#### Working Party on Brakes and Running Gear

#### Regulation No. 90 (Replacement brake linings)

## **Proposal for amendments to Regulation No. 90 (Replacement brake linings)**

### **Submitted by the experts from Italy\***

- "3. Brake disc design types for L category (examples)

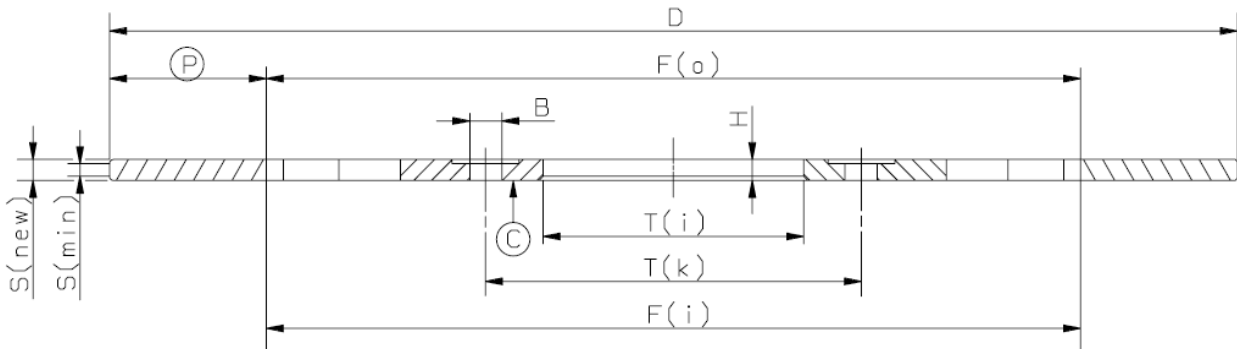
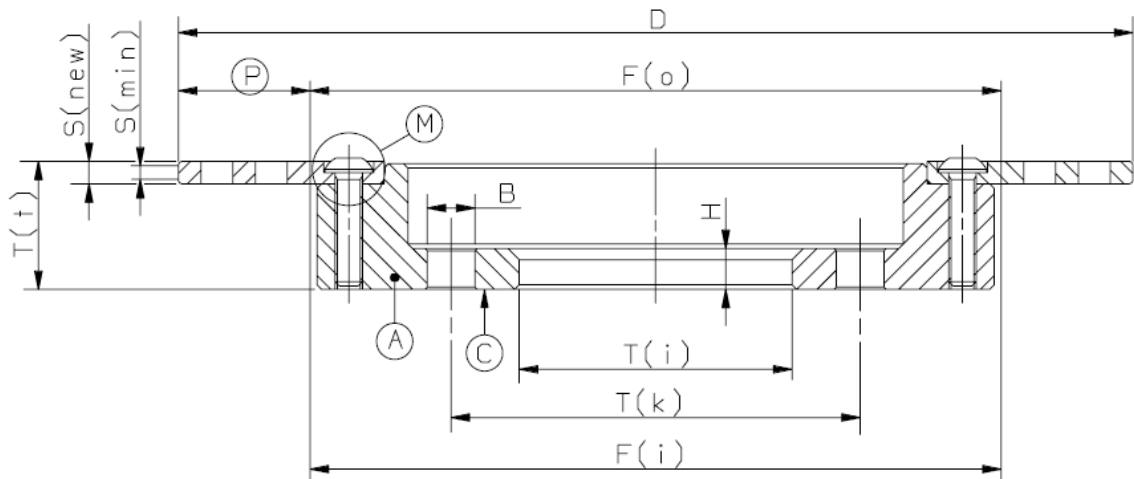
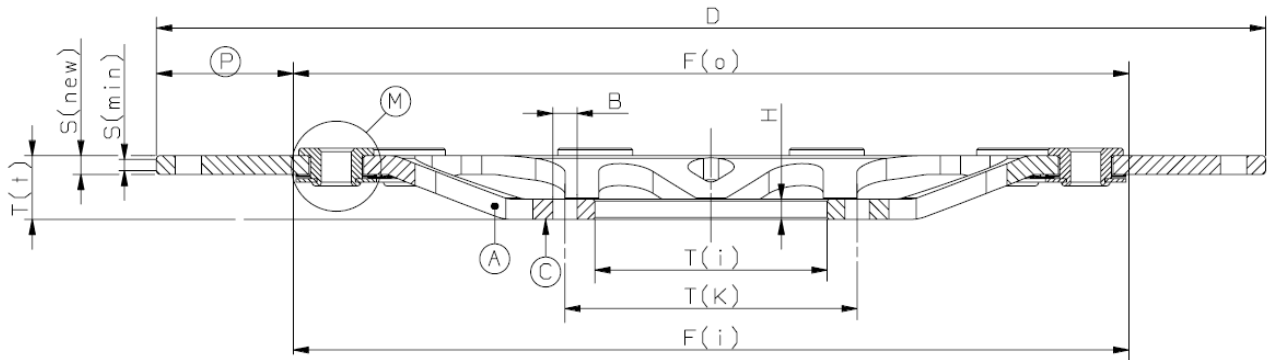
*Add a new Paragraph 3., to read:*

**One piece type: brake disc with braking surface and bell made in a single piece and therefore of the same material**

**Composed fixed type: brake disc having the braking ring made of steel, while the bell is of other material, generally aluminium; the 2 components are rigidly bounded by a screwed or riveted connection.**

**Floating type: brake disc having the braking ring radially released from the bell, in order to allow its thermal expansion.**

Figure 1

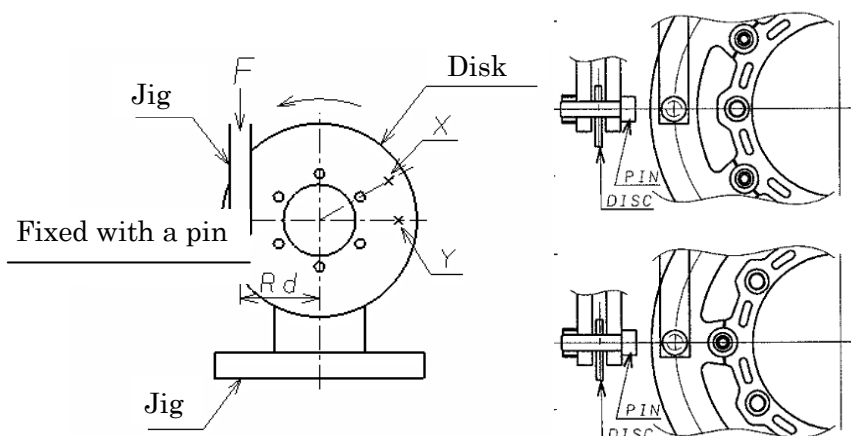
Static test performed on special test bench shown in Fig. 1.

- 2.2.1. Drill a hole on the braking surface of the disc at a distance from the centre equal to the effective radius  $R_d$ .
- 2.2.2. Position the disc on the test bench and fasten it using specific fastening screws.
- 2.2.3. Connect the bench arm to the hole drilled on the brake disc.
- 2.2.4. Apply the force  $F$ , specified in Table 2.1.2.5., as shown in Fig.1.
- 2.2.5. Record strokes and forces as shown in Fig. 2.

Figure 2 Movement

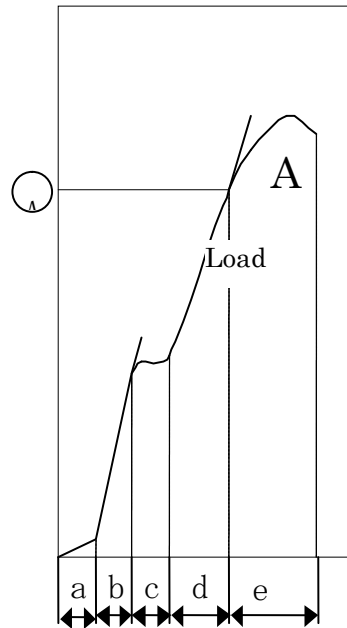
- 2.2.6. NB. The test shall be conducted in 2 positions:
  - 2.2.6.1. Floating and composite fixed disc
    - With hole on braking surface, coincident with a connection bush.
    - With hole on braking surface, coincident with the centre line between 2 connection bushes.
  - 2.2.6.2. One piece disc
    - With hole on braking surface, coincident with a fixing hole.
    - With hole on braking surface, coincident with the centre line between 2 fixing holes.

- (a) Adjustment stroke of the equipment (recovery of any clearance between the hole on the braking surface and the connection pin to the bench arm);
- (b) Load developed by the fastening screws to the equipment;
- (c) Movement of the brake disc caused by its rotation with sliding on the plate of the equipment, when the disc's fastening screws bear against the fixing holes of the disc;
- (d) Load supported by the brake disc;
- (e) Permanent deformation of the brake disc (starting from point A).

The disc does not have to undergo permanent deformations before reaching the force  $F$  specified in Table 1; the measurement of the deformation force must be performed at point A as per Fig.2.

Figure 3

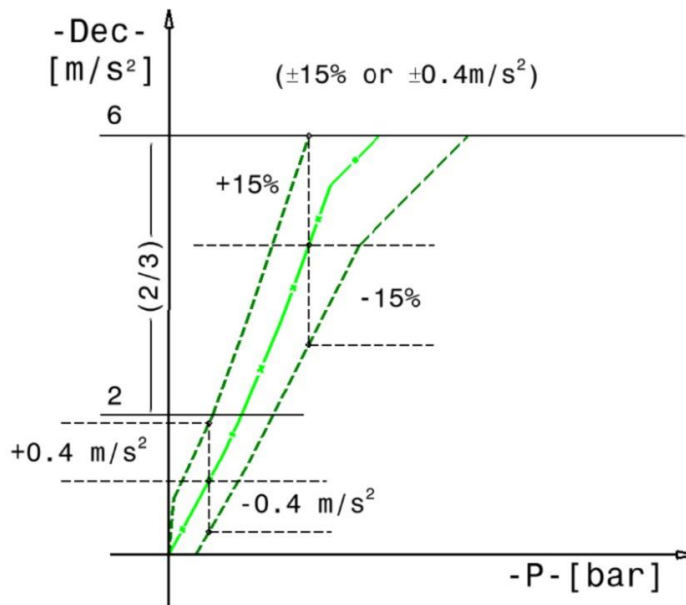
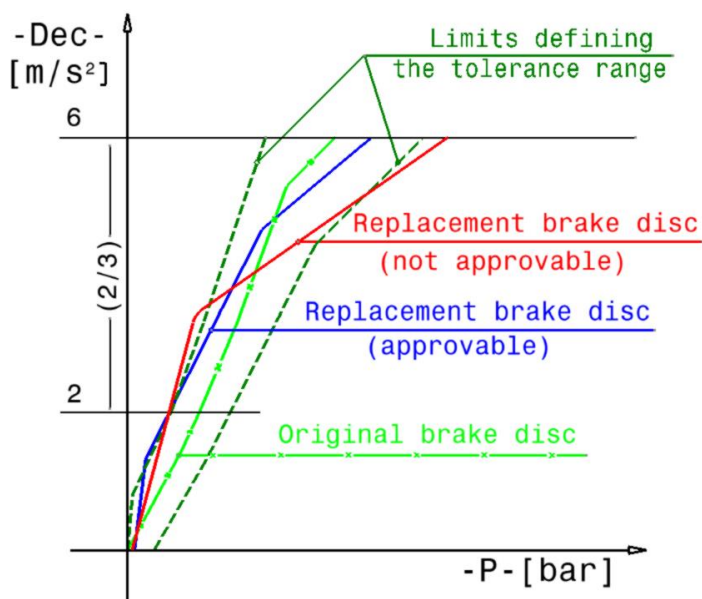
3.2.6.4. The dynamic frictional properties of the replacement brake disc can be regarded as similar to those of the original brake disc, provided the values attained in relation to the mean fully developed deceleration at the same operating pressures or control forces in the region of the upper 2/3 of the curve generated do not deviate by either  $\pm 15$  per cent or  $\pm 0.4 \text{ m/s}^2$  from those of the original brake disc (see an example of the curve in Fig. 3 and Fig. 4).

**Figure 1**

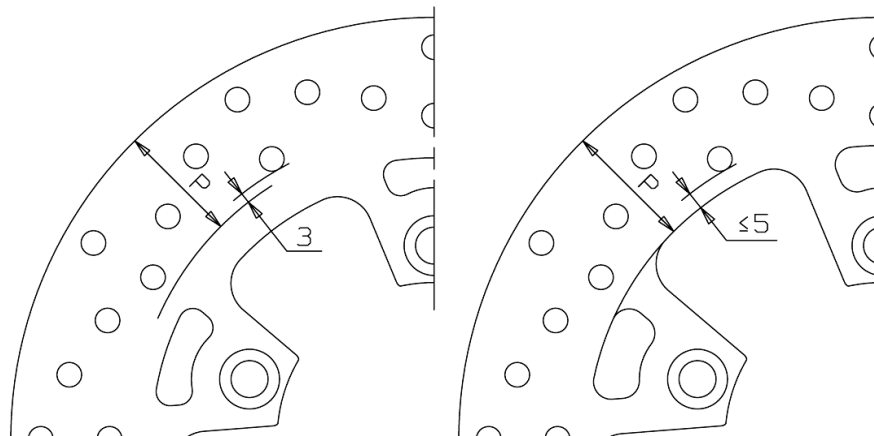
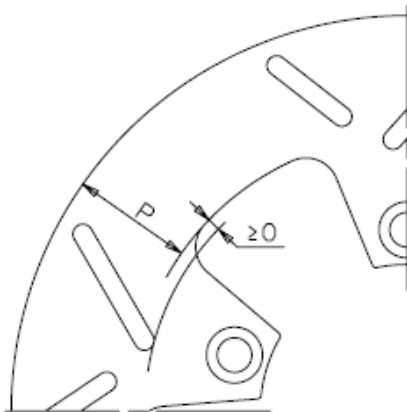
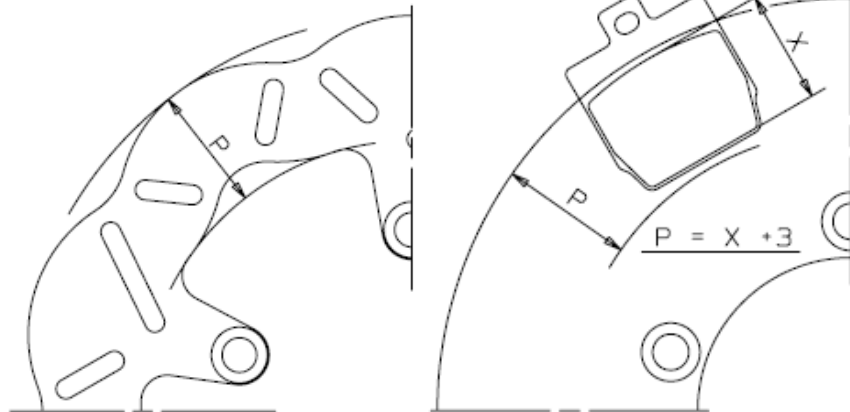
**Braking surface means the surface of a brake disc on which the brake pads work. The braking surface width is intended between the disc outer diameter and an internal diameter defined as follows:**

- 1.1. Case of braking surface with lightening (holes, slots, wave, etc.) on the braking surface (Fig. 1) only: 3 mm towards the centre of the disc from the end of the lightening.**
- 1.2. Case of braking surface with lightening (holes, slots, wave, etc.) with distance from the disc's internal diameter lower than 5 mm (Fig. 2): diameter of the brake disc undercut.**
- 1.3. Case of braking surface with lightening (holes, slots, wave, etc.) which terminate inside, outside the brake disc undercut (Fig. 3): diameter of the brake disc internal undercut.**
- 1.4. All other cases: internal diameter defined by the radial width of the largest combinable pad, to which 3 mm need to be added (Fig. 4).**
